ENCLOSURE 2  
 TENNESSEE VALLEY AUTHORITY (TVA)  
 BROWNS FERRY NUCLEAR PLANT (BFN)  
 UNITS 1, 2, and 3

PROPOSED TECHNICAL SPECIFICATION (TS) CHANGE TS-353  
 MARKED PAGES

II. MARKED PAGES

Fig. 2.1-2  
1.1/2.1-7

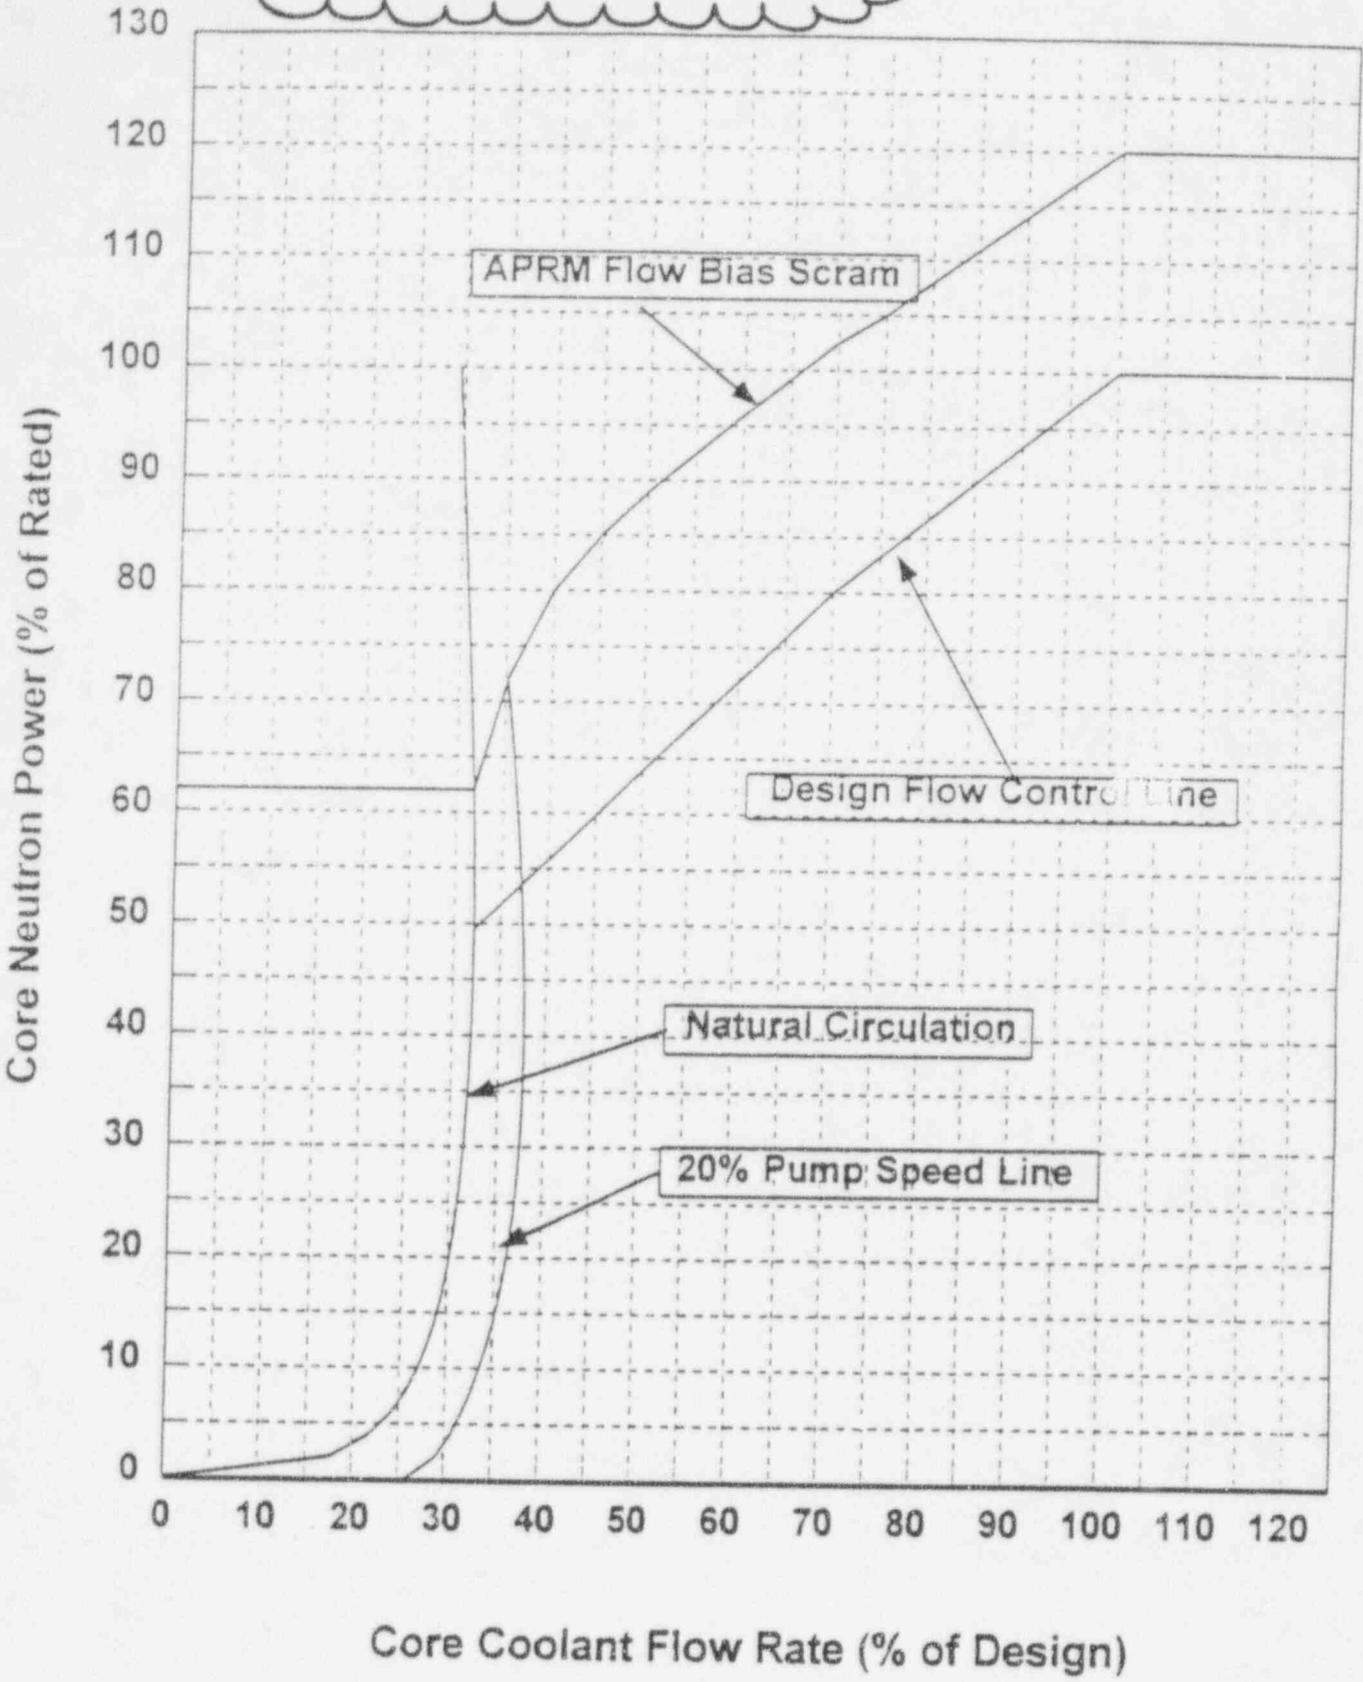
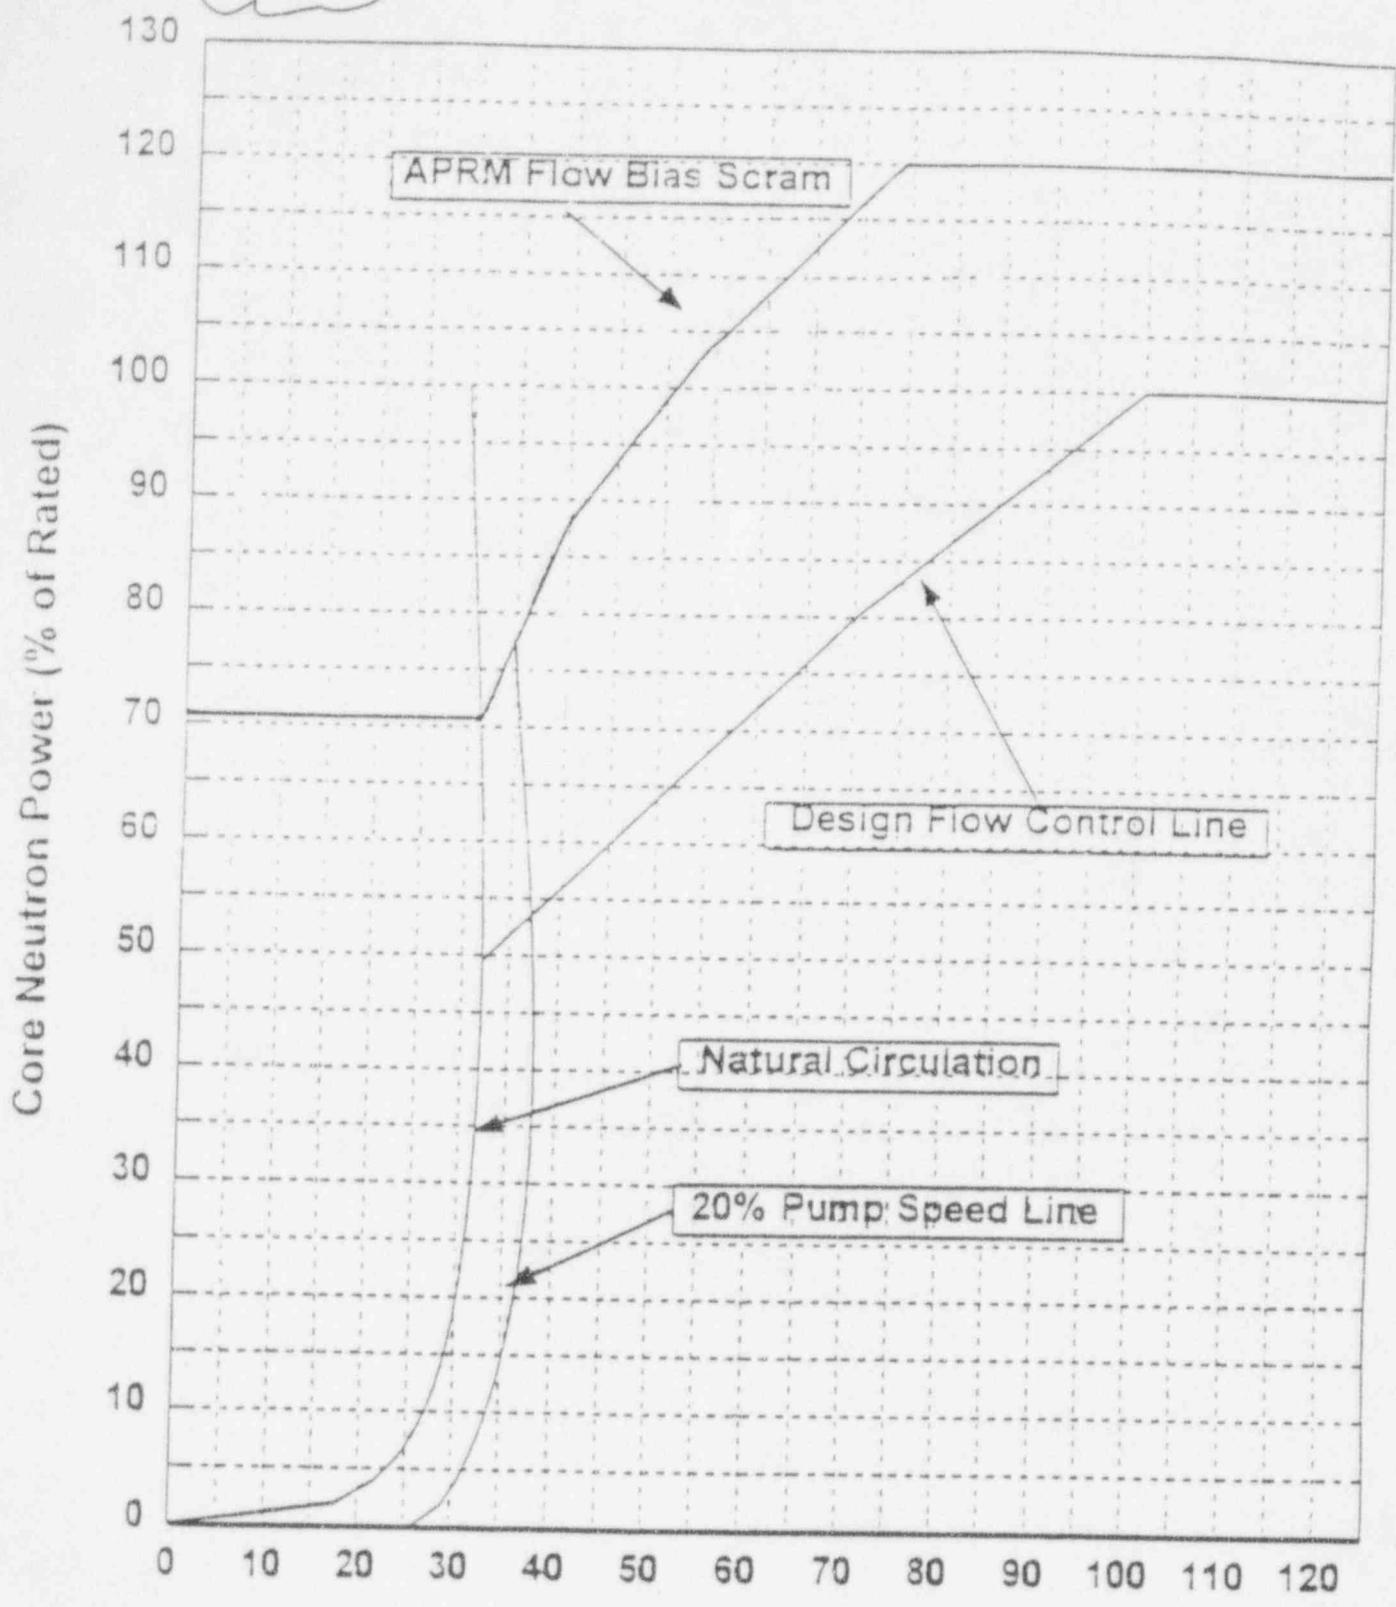
REPLACE WITH NEW FIGURE

New
